FLOODING PEER REVIEW FOR STATE SIGNIFICANT DEVELOPMENT APPLICATION (SSDA) AT 4-6 POPES ROAD, WOONONA (SSD-73910208), IN RESPECT OF DEPARTMENT OF PLANNING, HOUSING AND INFRASTRUCTURE RFI DATED 25 FEBRUARY 2026

Table 1 MA peer review of DPHI comments and ACOR responses.

Figure 1 1% AEP water level afflux from ACOR RFI Response (4 December 2025). (Max water level increases provided by ACOR on 6 March 2026).

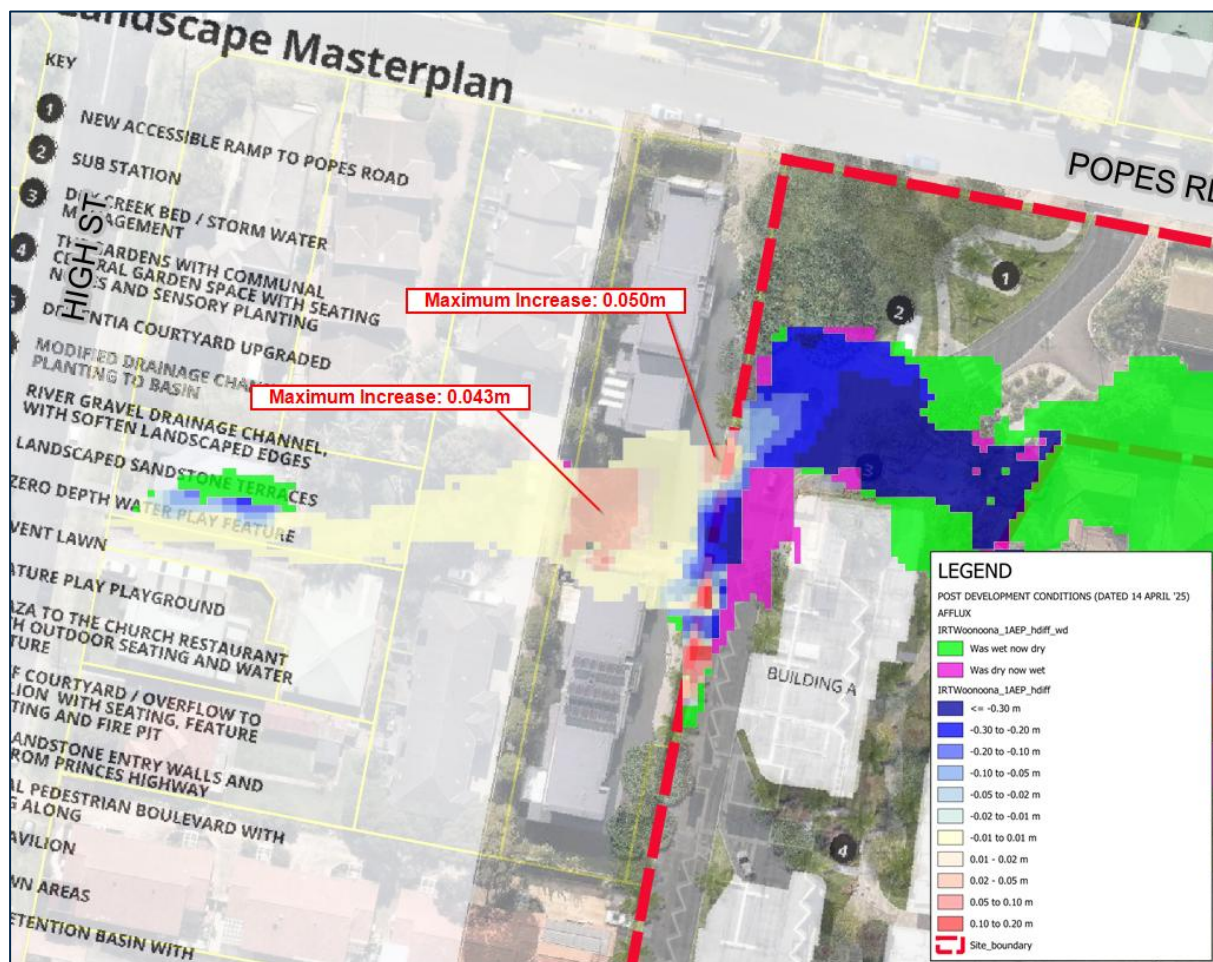
DPHI RFI	ACOR Response	MA Peer Review
1. Wollongong Local Environmental Plan 2009. The Department notes from Section 5 (and associated modelling) of the Flood Report prepared by Acor, dated 26 May 2025 that the proposal is likely to increase flooding impacts upstream of the western boundary. Please investigate and resolve this likelihood of upstream flooding, having regard to clause 5.21 of the Wollongong LEP which seeks "to avoid adverse or cumulative impacts on flood behaviour and the environment"	1. Wollongong Local Environmental Plan 2009 Response: Flood impact maps were updated after Flood Report by ACOR Consultants dated 26 May 2025, with flood impact maps presented in ACOR letter IRT Woonona – SSDA Response dated 4 December 2025. In response to Clause 5.21 of the Wollongong LEP 2009, inspection of model results shows that increases in water level in the 1% AEP event on 2 Popes Road (CPI-/SP96287), upstream of the western boundary, are between 10-43 mm and are contained in a localised area of the open channel upstream of the inlet of the culvert under the driveway. These localised impacts are not likely to cause an actionable nuisance and do not have the potential to worsen the use or enjoyment of the land. Flood impacts are not evident upstream of the western boundary for the 20% AEP event, and negligible and localised within the open channel in the 10% and 5% AEP events.	At Figure 1 and Figure 2 (Attachment A of this letter), we have reproduced the 1% AEP and 1% AEP with climate change impacts to the west of the site including the maximum water level increases. We agree that the impacts further west are confined to within the open channel under both the 1% AEP and 1% AEP with climate change events. Impacts closer to the site boundary are confined immediately behind a solid brick wall north of the existing fence opening. Existing 1% AEP (with and without climate) hazards in this area are already H5 and are unchanged by the proposed development and thus will not affect the safe use of the driveway. Overall, these impacts are considered acceptable, as they do not affect neighbouring buildings or the driveway and would not impact the existing land use of the adjacent land.
